Product Change Notification: E-18-018910

PCN Date: 23-JAN-19

General Product Description:
Modifications of RM relay cap

PIC 3

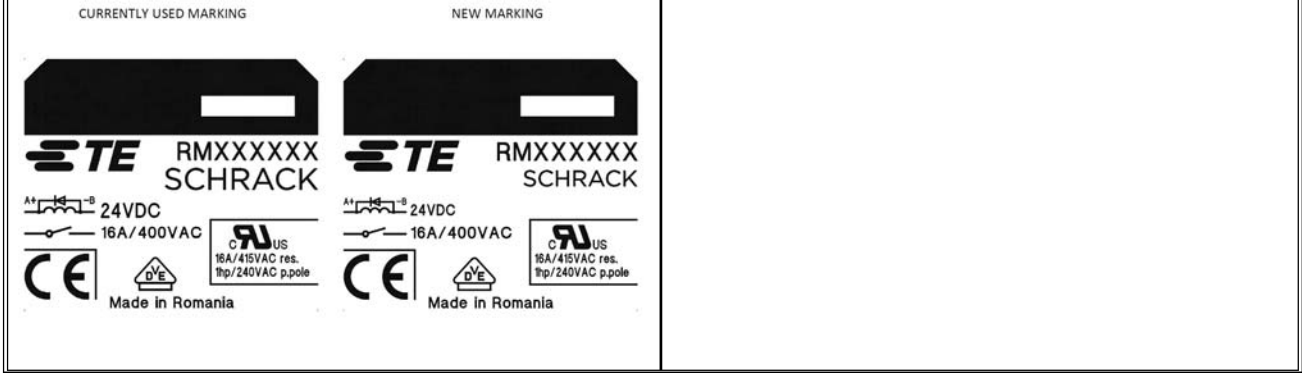
Description of Changes
During maintenance of the RM relay cap tool, the inner roughness was slightly softened in order to increase the readability of the cap printing - see pic 1. Besides that, the snap-in location of cap to base looks now a little bit different due to tooling reasons - see pic 2. Further, the printing on the top of the cap was slightly rearranged to improve printing quality - see pic 3. All these modifications do not have any influence of the specification or behavior of the relay.
